# Posocco Equities 1569 Blue Barn Road

Major Plan 2024-106

**SUBJECT:** Posocco Equities 1569 Blue Barn Road  
Major Plan 2024-106  
Sketch Plan Review

SUBJECT: South Whitehall Township  
1569 Blue Barn Road  
Major Plan #2024-106  
Sketch Plan Review

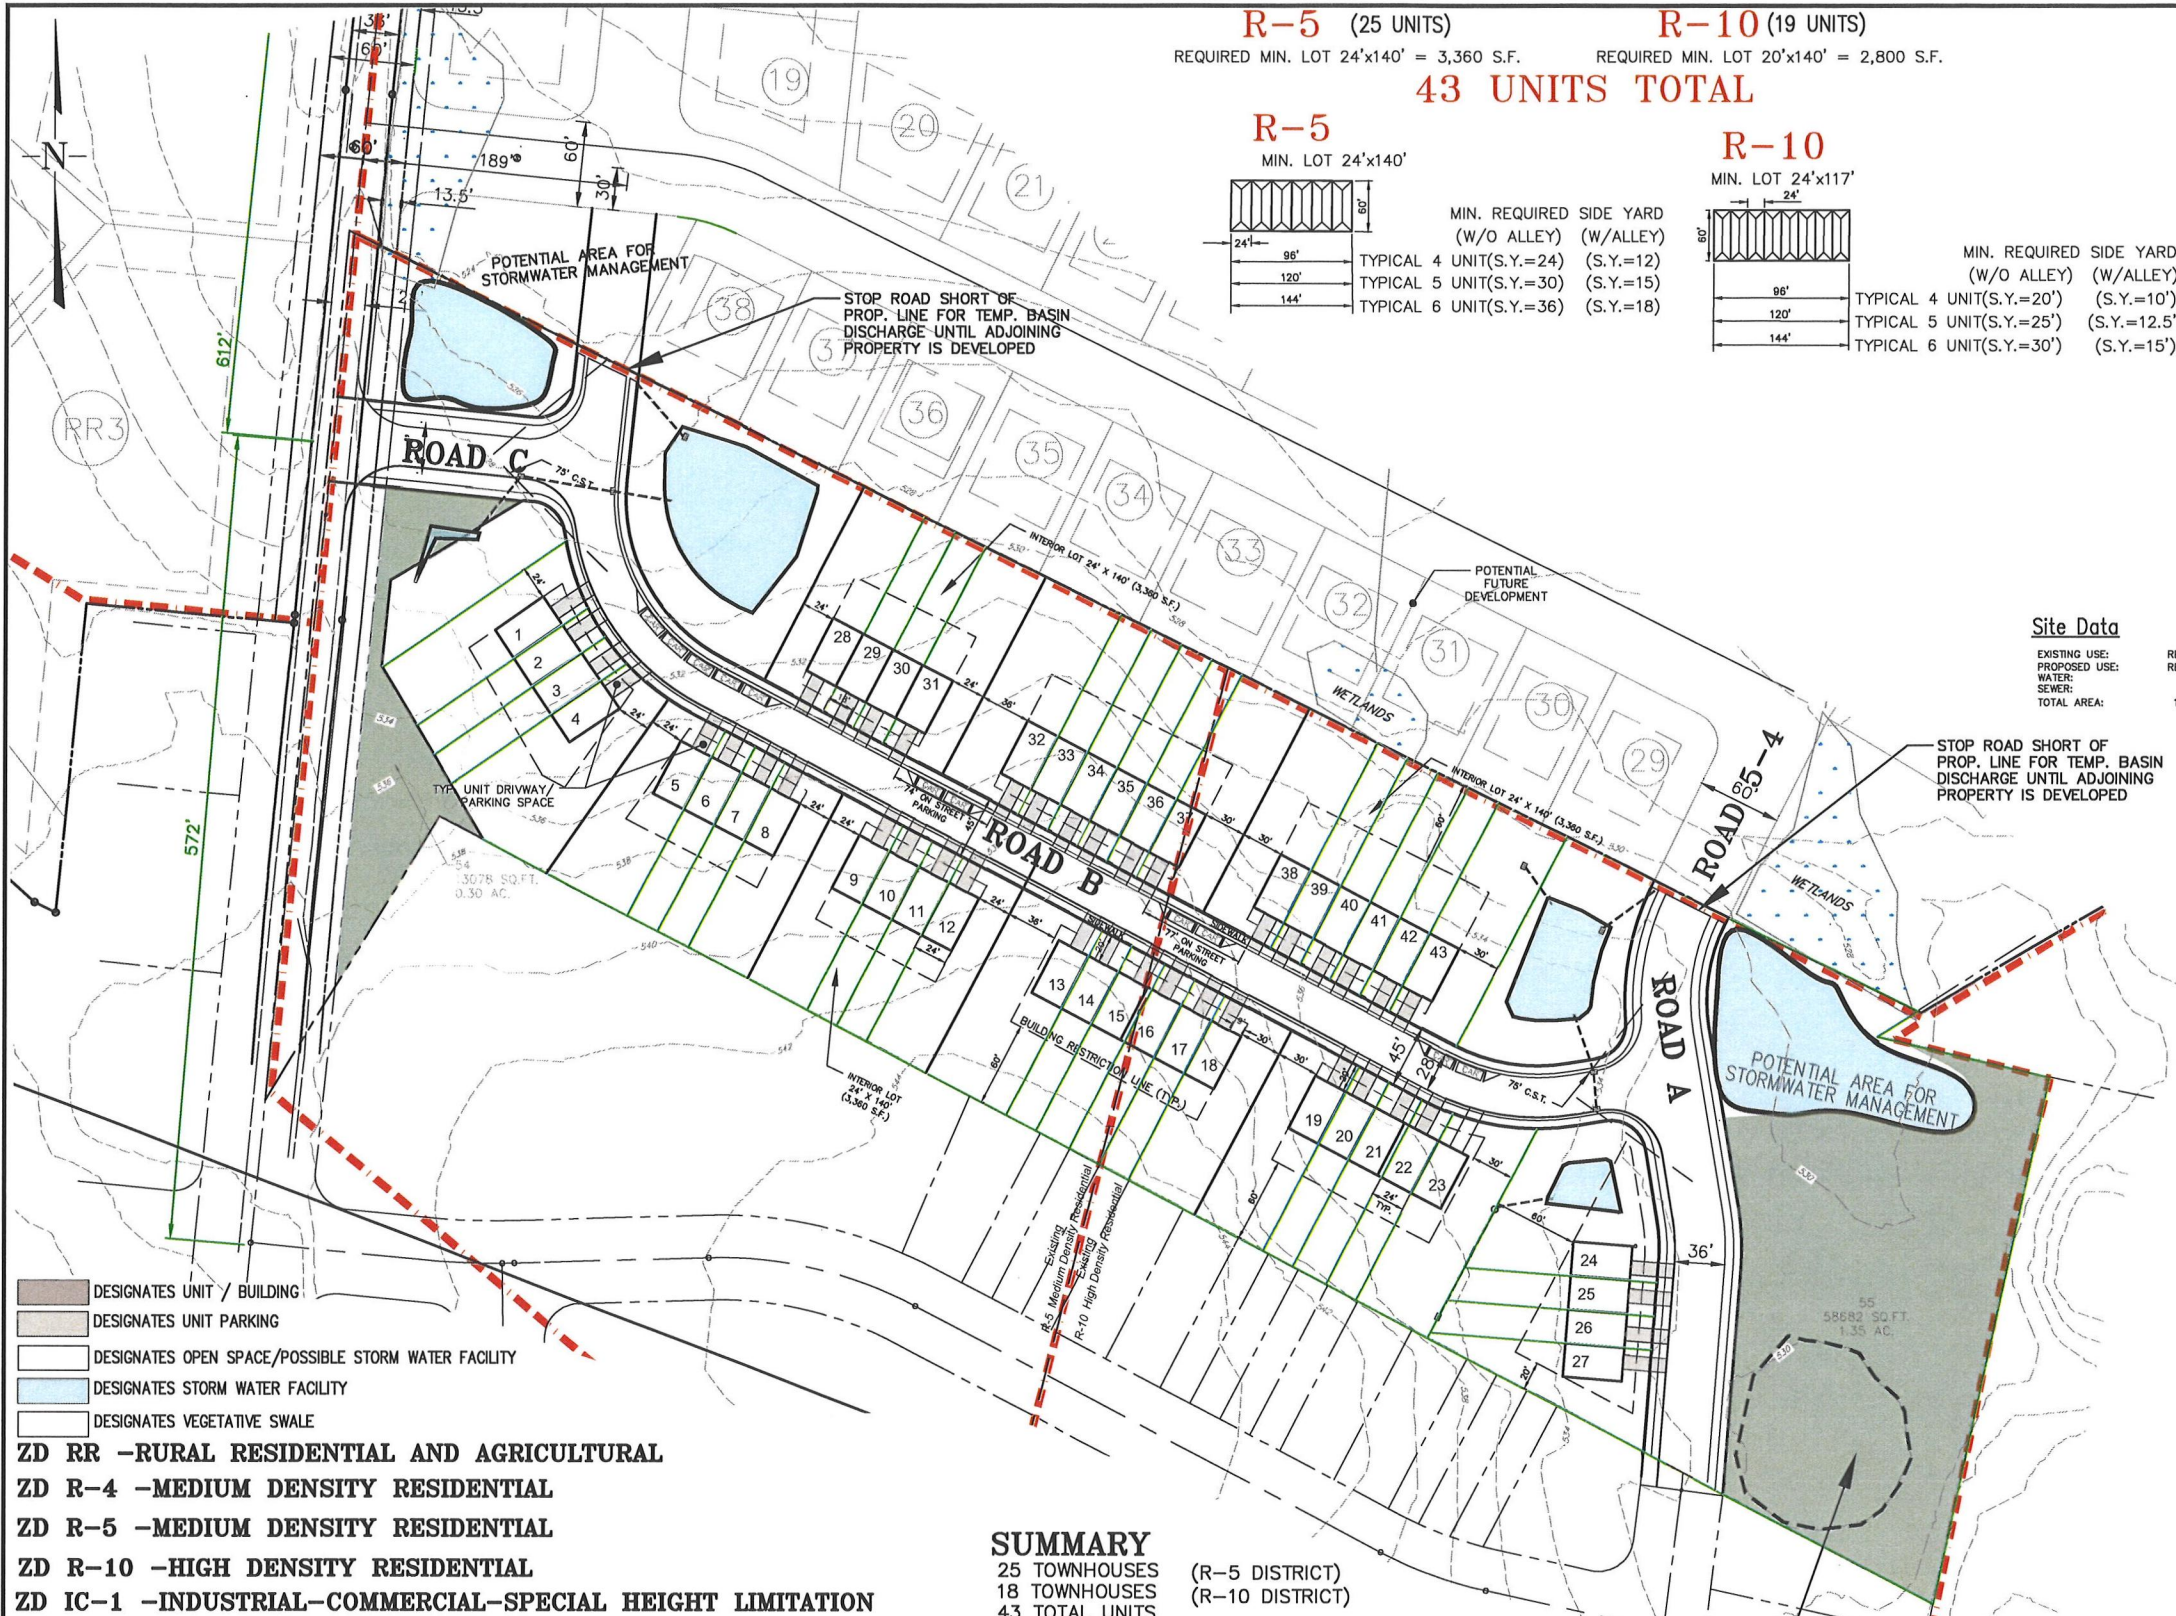
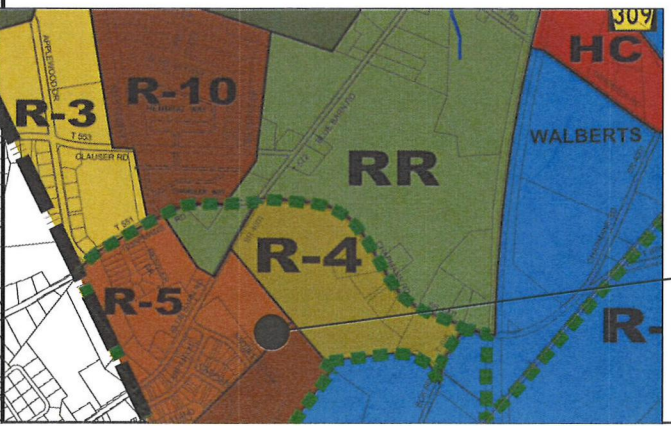
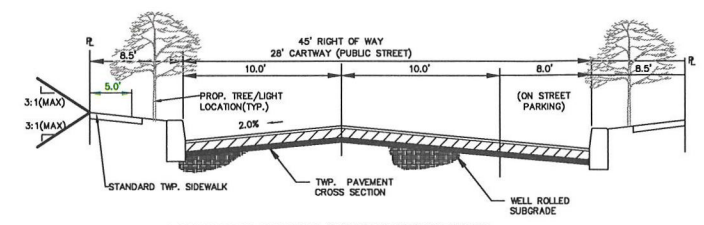
1. The project is in the Jordan Creek Watershed Act 167 Subareas 116 and 118 which are 30/100 percent release rate districts. Stormwater management system plans and design calculations which demonstrate that the proposed development will meet the Act 167 runoff requirements for discharge to any contiguous properties should be submitted for review with the Preliminary Plan;

2. Show Blue Barn Road frontage improvements meeting the requirements for a minor arterial road, which requires an 80-foot right-of-way and 50-foot cartway, curb, sidewalk, concrete monuments, street trees, etc. Account for these road improvements in the drainage, utility, and landscaping designs, SALDO §312-26 and §312-35;

3. Confirm with the Township the acceptability of the 45-foot right-of-way/28-foot cartway proposed for Road “B”. SALDO §312-35(b)(3)(D)(i) permits an alternate Local Street Cross Section with a 40-foot right-of-way and a 28-foot cartway with prior approval (Local Street Standards require 60-foot right-of-way/36-foot cartway). Also, confirm with the Township the acceptability of proposed on-street parking. At a minimum, parking on the inside of horizontal curves should be avoided;

4. Coordinate internal connections with the adjacent Blue Barn Road Subdivision. Obtain any easements/rights-of-way for any off-site work. Note temporary cul-de-sacs should be provided for sub streets greater than 200 feet in length and Type III barricades meeting the Township specifications shall be placed at every stub street, SALDO §312-35(b)(2)(B)(ii);

5. 800-foot offsets are required between the centerlines of Road “C” and Saddlebred Road (572± feet provided) and between Road “C” and Chapmans Road (630± feet provided), SALDO §312-35(a)(6)(E)(i). A waiver of this requirement should be discussed with the Township;

- b. Show the proposed design speed for the proposed Roads. Revise the horizontal geometry to support a 25-mph speed limit or adjust the anticipated speed limit accordingly, SALDO §312-35(b)(3)(A)(v);

- c. Revise the street design to provide 100 feet between a curve and a street intersection, SALDO §312-35(b)(3)(A)(v); and

- d. Revise the clear sight triangles on the plan to be in accordance with SALDO §312-35(a)(6)(F) – based on PennDOT Intersection Sight Distance criteria. Also provide required and available sight distances at the Road “C”/Blue Barn Road intersection, SALDO §312-35(a)(6)(F).

7. Provide the following Sketch Plan information in accordance with SALDO §312-10(b):
- a. A signed Applicant’s statement per SALDO §312-10(b)(4);
  - b. Identify Tract 1 and Tract 2 on the plans. Confirm Tract 2 information (e.g., Tax Parcel, Doc ID, etc.), SALDO §312-10(b)(5)(G);

- c. Impervious cover limits for each lot and driveway separation distances, SALDO §312-10(b)(5)(H);
  - d. The basis of the contour information (e.g., USGS), SALDO §312-10(b)(8);

- e. Show adjacent property boundaries within 200 feet of the site, SALDO §312-10(b)(10);
  - f. Show any proposed project staging, SALDO §312-10(b)(11);

- g. Check the Zoning District boundaries shown for consistency with the Township Zoning Map, SALDO §312-10(b)(14). Also, show/label the adjoining Zoning District Boundaries (e.g., R-10/IC-1, R-5/RR, R-5/R-4, etc.) on the Plan;

- h. The Official Map – Component 1, indicates portions of the site are in the Groundwater Recharge Basin, on Slopes between 15 and 25 percent, and in Woodlands Areas. Development in these areas should be reviewed with the Township Staff, SALDO §312-10(b)(14);

- j. Show the proposed limits of public and private facilities (e.g., items to be owned/maintained by any Homeowners’ Association, etc.). Confirm the ownership intentions for the open space lots and detention basin lots, SALDO §312-10(b)(14);

- k. Plans of adjacent developments (e.g., Blue Barn Meadows and Blue Barn Road Subdivision) show a 50±-foot wide Buckeye Easement along the eastern most tract boundary. Confirm the location of the existing easement and show it accordingly on future plans. Provide evidence of approval by Buckeye Pipeline for any work within its easement, SALDO §312-10(b)(14); and

- l. The Township should determine whether open space, or fees in lieu of, will be required, and an appropriate note should be placed on a Preliminary Plan, SALDO §312-34(d). Also, clarify the Prime Open Space areas, SALDO §312-10(b)(14).

1. No utilities shown to provide comments.

1. Sanitary sewer must be pumped to the existing SWT Collection System or flow by gravity to the south into the Blue Barn Meadow Development or other point in the SWT Collection System.

3. *South Whitehall Landscapes* is the Township's Open Space, Historic, Agricultural, and Natural Resources Preservation Plan. This project proposes 1.80 acres of dedicated open space, but the proposed use of that open space is unclear. More details on proposed uses of open space should be provided, with consideration to the Open Space Classifications identified in the *South Whitehall Landscapes* plan.

1. The Permitted Building Heights listed in the Site Data Table may need to be revised, ZO §350-24(c)(7) and §350-24(c)(8); and
2. Setbacks/buffers from the IC-1 Zoning District and the proposed adjoining single-family residential units may be required, ZO §350-42(b);
3. A variance from ZO §350-48(d)(8)(E)(iv) regarding the provision of an alley behind townhouses is requested; and
4. The acceptability of the parking may need to be determined. The Applicant proposes the use of 1 garage space as well as the use of on-street parking spaces for townhouse overflow parking the acceptability of which may need to be confirmed, ZO §350-48(d)(8)(D).
